Subject: As-Built Plan Review
1 Godwin Ave., LLC
Sola Salon
1 Godwin Ave.
Block 3, Lot 24.01
LAN Ref. #2.2428.257

LAN Associates Engineering, Planning, Architecture, Surveying, Inc. (LAN) is in receipt of an as-built plan of the subject property prepared by Page Consultants, Inc., dated 11/16/22. LAN has visited the site and reviewed the plan, and some revisions will be required. The as-built should accurately reflect the as-built conditions at the site.

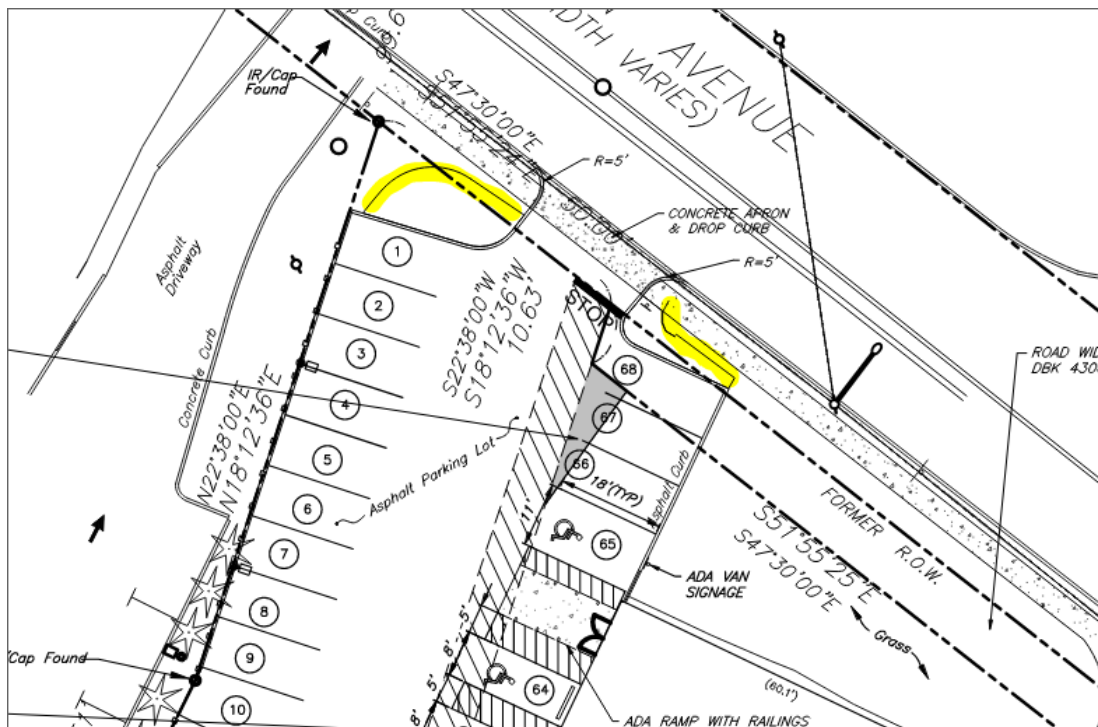
1. As shown on the as-built plan, these highlighted areas represent the old edge of pavement at the Godwin Ave. driveway. These old lines should be removed from the as-built drawing.

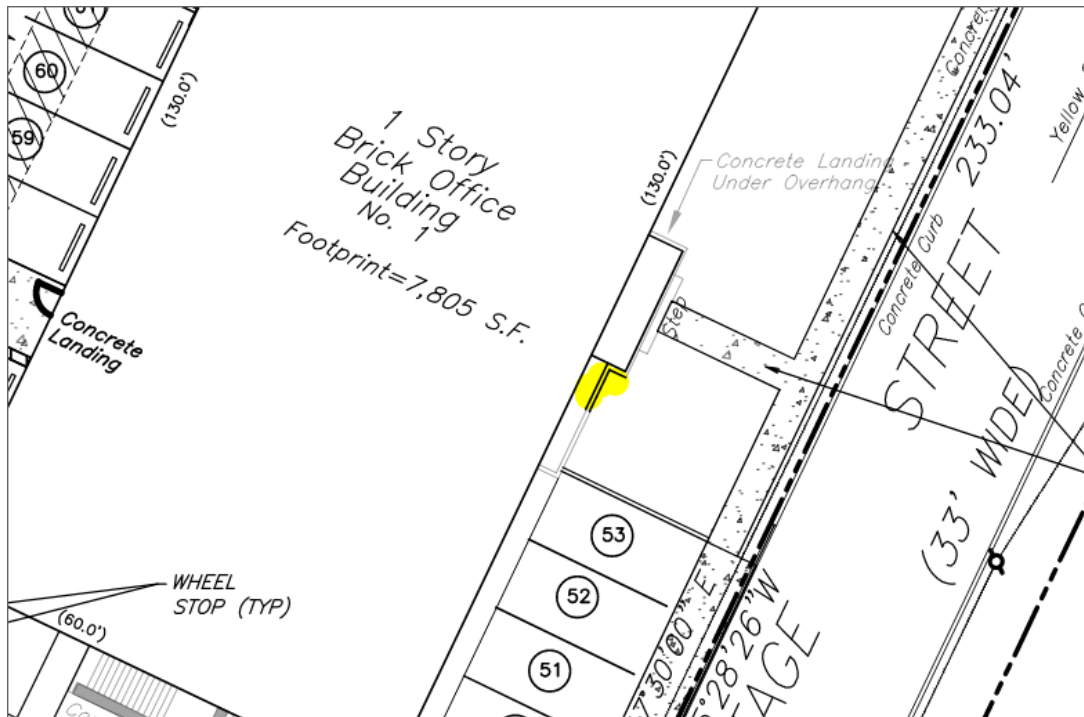
2. This highlighted area does not appear to be accurate. There are natural stone landscape walls on either side of these stairs. Accurate as-built conditions should be shown on the as-built plan.
